**ADDENDUM NO. 1**

**DATE:** September 28, 2017

**FOR:** CLARK COUNTY BRIDGE NO. 18400061  
BRO-B032(27)

GENERAL NOTES AND QUANTITIES SHEET  
OFF SYSTEM BRIDGE REPLACEMENT PROGRAM  
CART ROAD NO. 184 PROJECT #BRO-B023(27) BRIDGE #18400061  
CLARK COUNTY, MISSOURI

**REVISED PLAN SHEET 2**

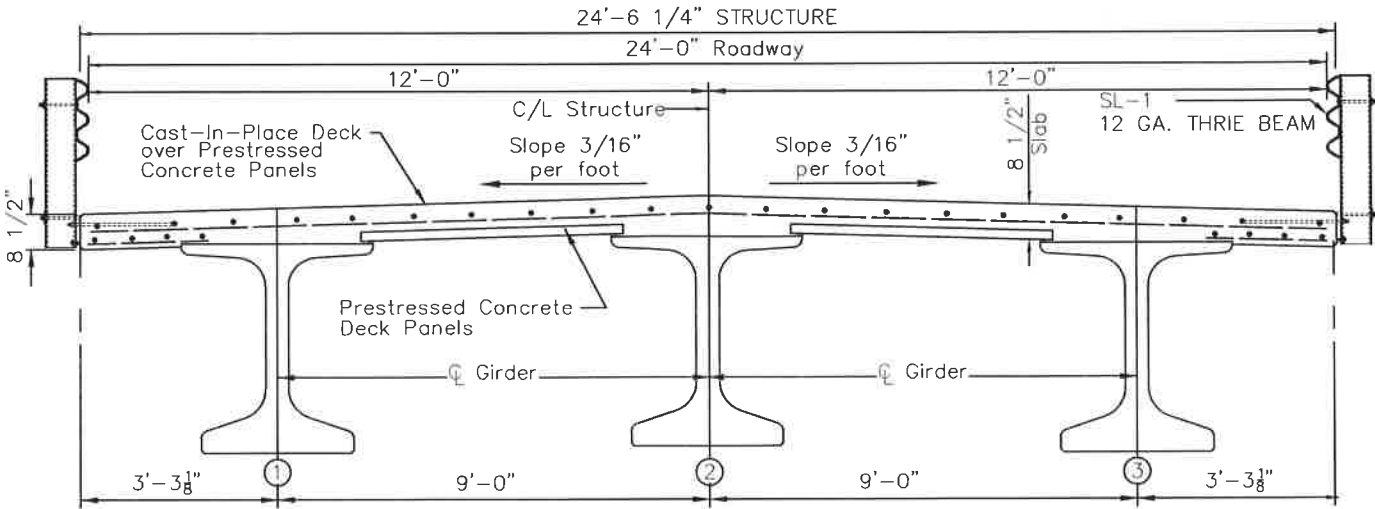
Sheet 2 of the project plans has been updated to adjust concrete quantities. The Pay Item "Class B-2 Substructure Concrete" has been removed. The note separating the furnishing and placement of concrete from the drill shaft and rock socket pay items has been removed. All cost associated with the Drilled Shafts and Rock Sockets shall be included in the pay items "Drilled Shafts (3'-6" Dia.)" and "Rock Sockets (3'-0" Dia.)" per MoDOT Standard Specifications.

---(Note Deleted)---

Concrete for Drilled Shaft and Rock Socket shall be MoDOT class B-2, All other substructure concrete shall be class B-1.
